Georgia Power Company  
Vogtle Electric Generating Plant Unit 1  
Detailed Control Room Design Review  
Supplemental Summary Report

# DCRDR SUPPLEMENTAL SUMMARY REPORT

This report provides additional information requested by the Nuclear Regulatory Commission in their Safety Evaluation Report on the Vogtle Electric Generating Plant (VEGP), Detailed Control Room Design Review. (DCRDR) The report also contains additional information requested as a result of the NRC audit of the DCRDR and the VEGP Safety Parameter Display System (SPDS).

# UNIT 1 CONTROL ROOM TEMPERATURE & HUMIDITY

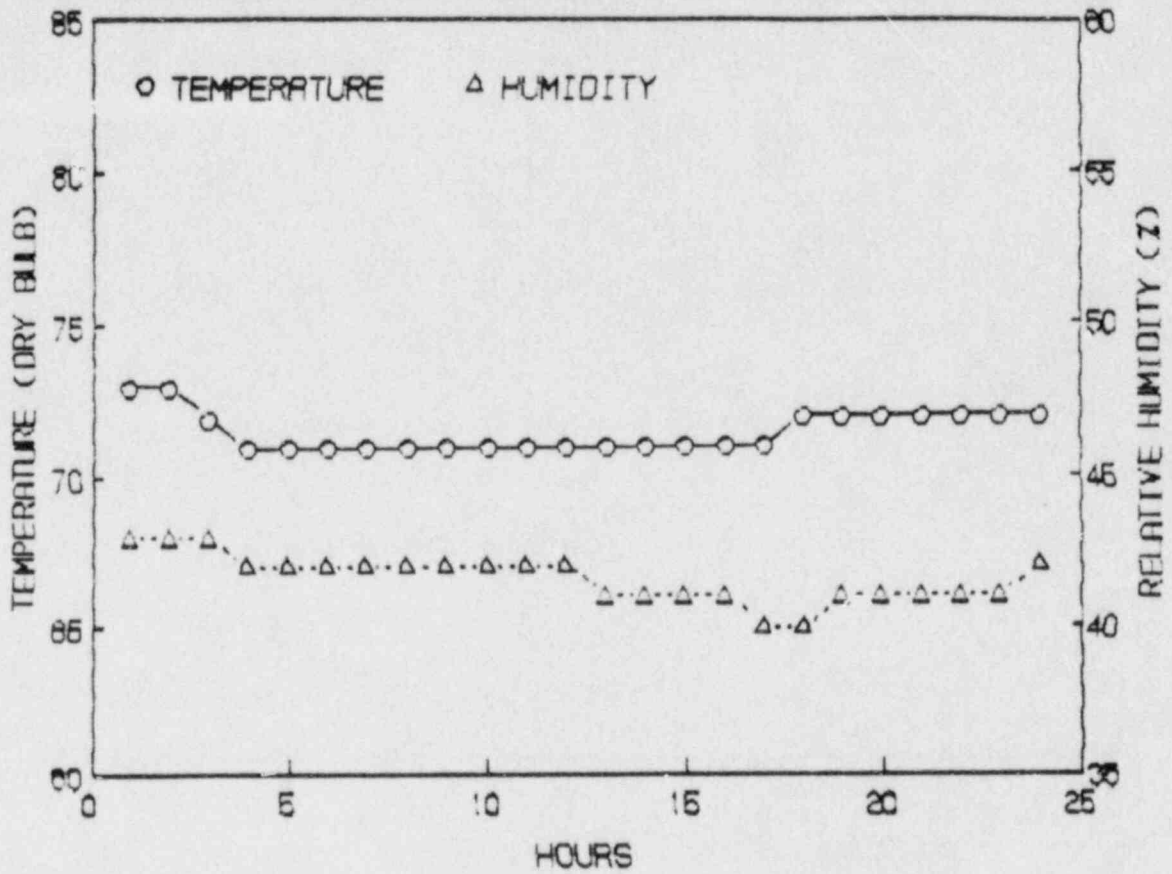
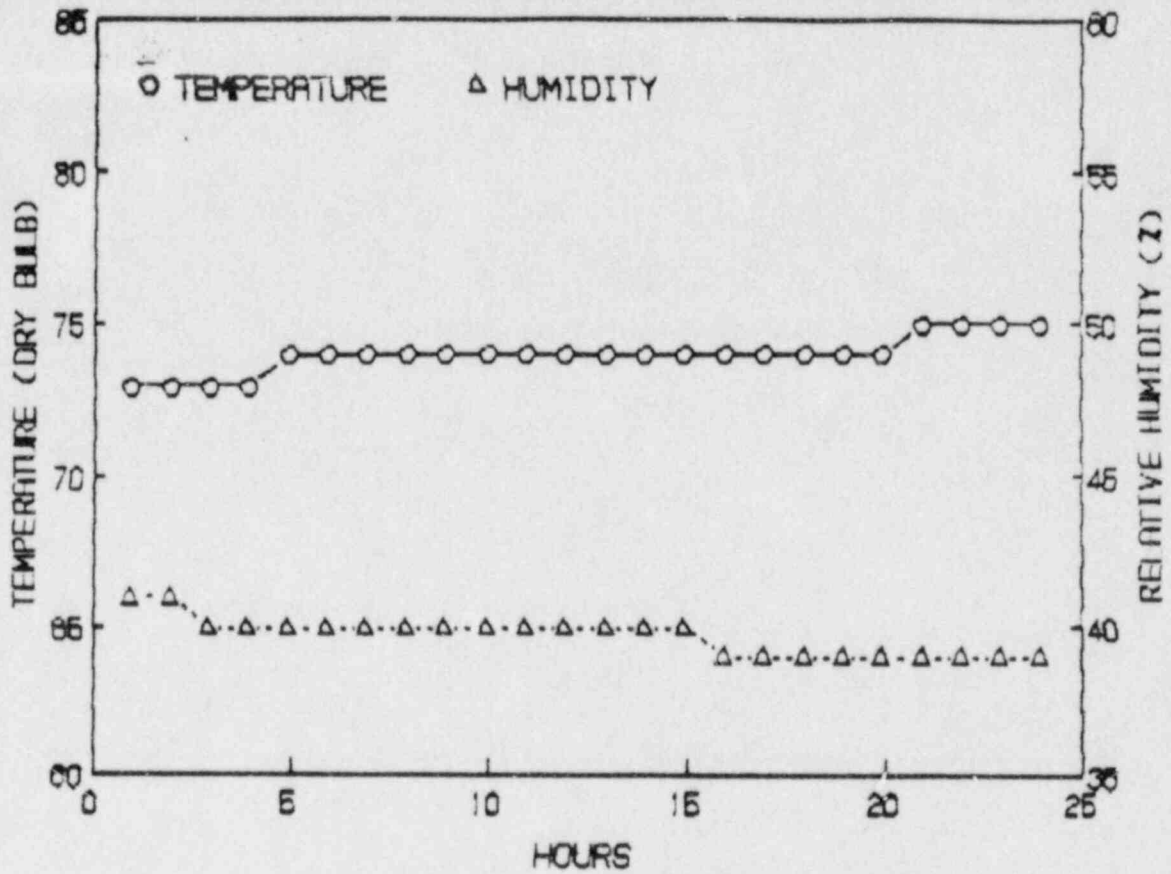
The Nuclear Regulatory Commission (NRC) expressed a concern, by letter dated May 4, 1987, that the Control Room temperature may be too low. Additional temperature and humidity surveys were requested by the NRC.

Although the data indicate that the average Control Room temperature is at the lower limit recommended in NUREG 0700, Section 6.1.5.1, and Operator surveys show 70% feel the control room climate is sometimes too cold, it should be pointed out that the Vogtle Control Room HVAC system is sized to serve both the Unit 1 and Unit 2 Control Rooms.

An air tight construction interface barrier currently separates the two Control Rooms and the HVAC system is not subjected to the heating and air conditioning loads expected during two unit operation. The construction barrier is scheduled to be removed in October 1988. The final Control Room environmental surveys will be conducted as part of the Unit 2 DCRDR when both Control Rooms are fully interconnected.

# UNIT 1 CONTROL ROOM TEMPERATURE

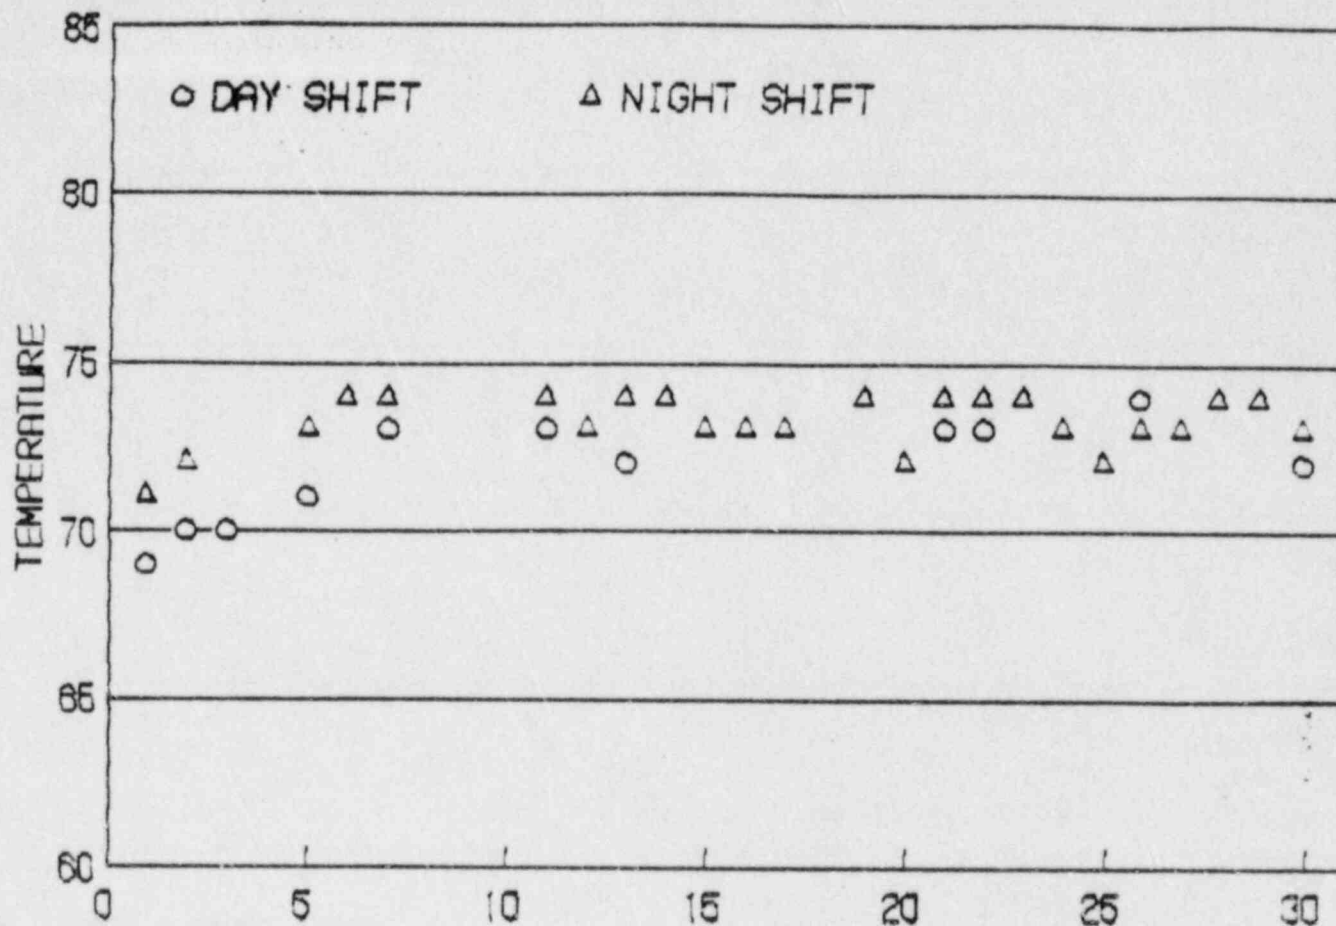
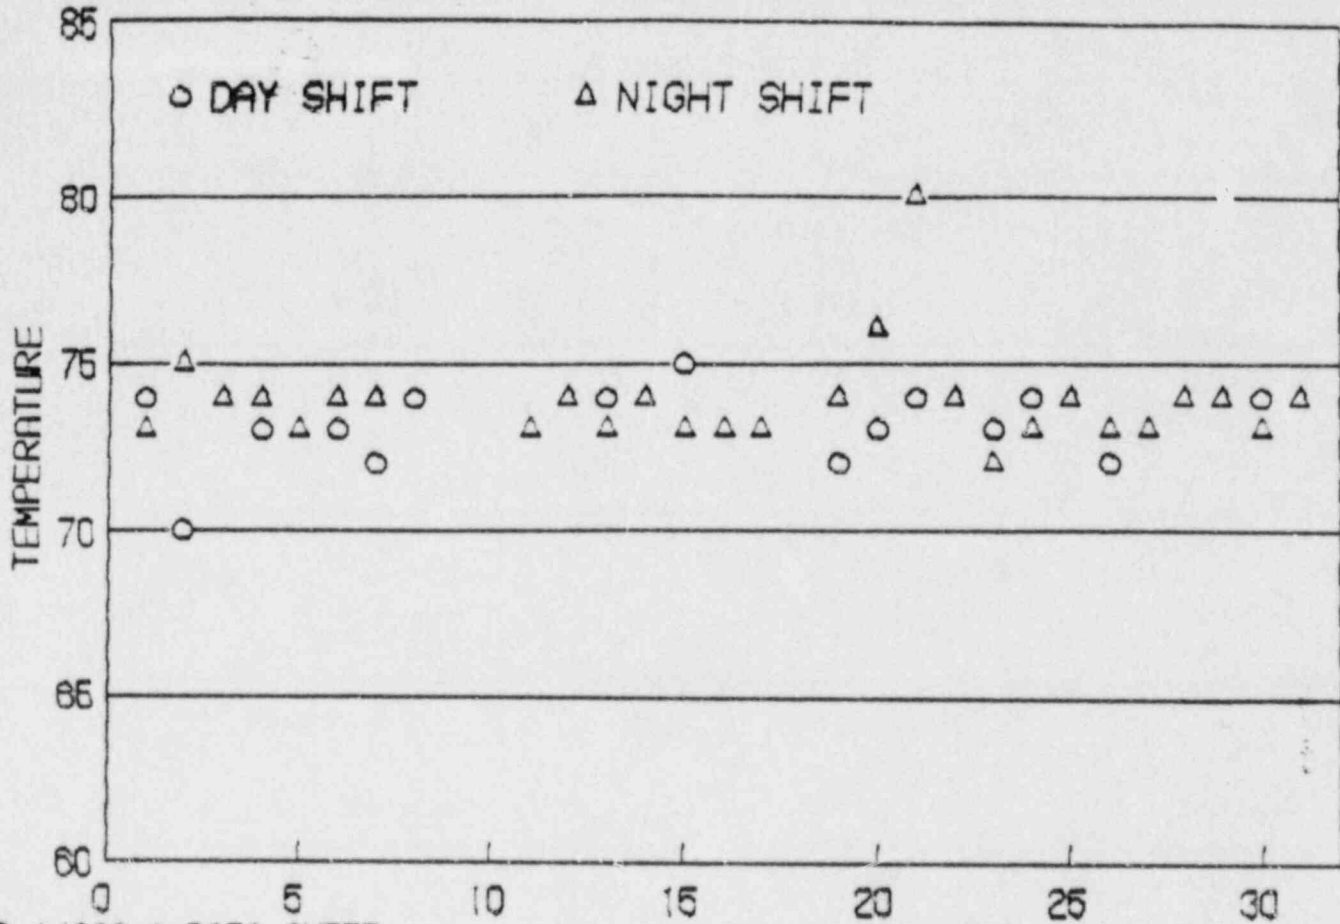
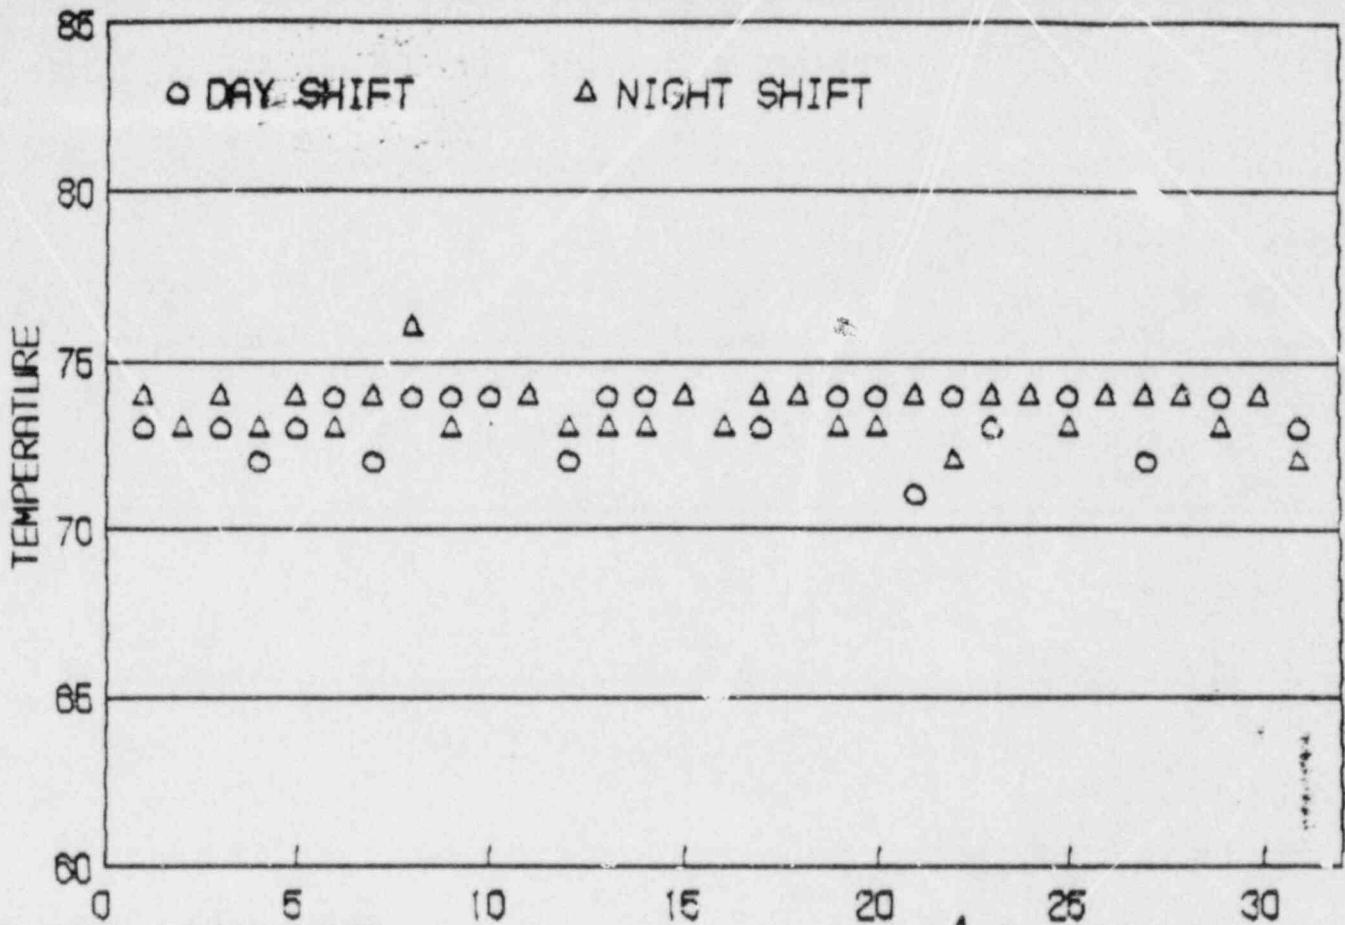
For the summer months of June, July and August 1987, the Control Room temperature recorded twice each day for Technical Specification 3.7.10 was reviewed. These data are illustrated in Figures 3-1 through 3-2. Table I.A.3.3 summarizes the results of the Three Month Temperature Survey.
